# Access Compliance Report

## Public Rights-of-Way

Intersection ID: 15064	Main Street: MONROE_RD	Cross Street: WASHBURN_AV	Location: E
ADA ID: E455BBBBDBD7	Ramp Type: Perp	Initial Pass/Fail: Fail	Overall Compliance: No
Severity Score: 22.5			
Codes/Mitigation Info/Possible Solution		Field Measurements/Component Compliance

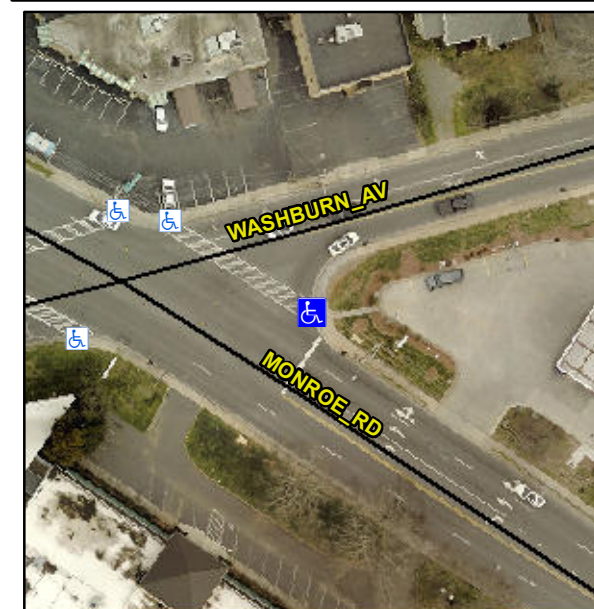
**Not Found, R304.5.1, R304.2.2**

Compliance	Description	Data	Compliance	Description	Data
N/A	Ramp Length (in)	91.5	No	Ramp Slope (%)	9.9
No	Ramp Width (in)	46.5	Yes	Ramp XSlope (%)	4.8
N/A	Flare Type LT	N/A	N/A	Flare Type RT	N/A
N/A	Flare Slope LT (%)	N/A	N/A	Flare Slope RT (%)	N/A
N/A	Flare Traversable LT?	N/A	N/A	Flare Traversable RT?	N/A
N/A	Landing Length (in)	N/A	N/A	DWS Provided?	N/A
N/A	Landing Width (in)	N/A	N/A	DWS Contrast?	N/A
N/A	Landing Slope (%)	N/A	N/A	DWS Length (in)	N/A
N/A	Landing X Slope (%)	N/A	N/A	DWS Full Width?	N/A
N/A	Landing Curb? (Y/N)	N/A	N/A	DWS Offset (in)	N/A
N/A	Shared Landing?	N/A			
N/A	Gutter Ponding?	N/A	N/A	Gutter Slope (%)	N/A
N/A	Gutter Lip Ht (in)	N/A	N/A	Gutter X Slope (%)	N/A
N/A	Painted X Walk1?	Yes	N/A	Painted X Walk2?	N/A
	X Walk 1 Direction	To NW		X Walk 2 Direction	N/A
N/A	X Walk 1 Width (in)	106.0	N/A	X Walk 2 Width (in)	N/A
	X Walk 1 Slope (%)	4.0		X Walk 2 Slope (%)	N/A
	X Walk 1 X Slope (%)	8.3		X Walk 2 X Slope (%)	N/A

**Remove & Replace Entire Ramp.**
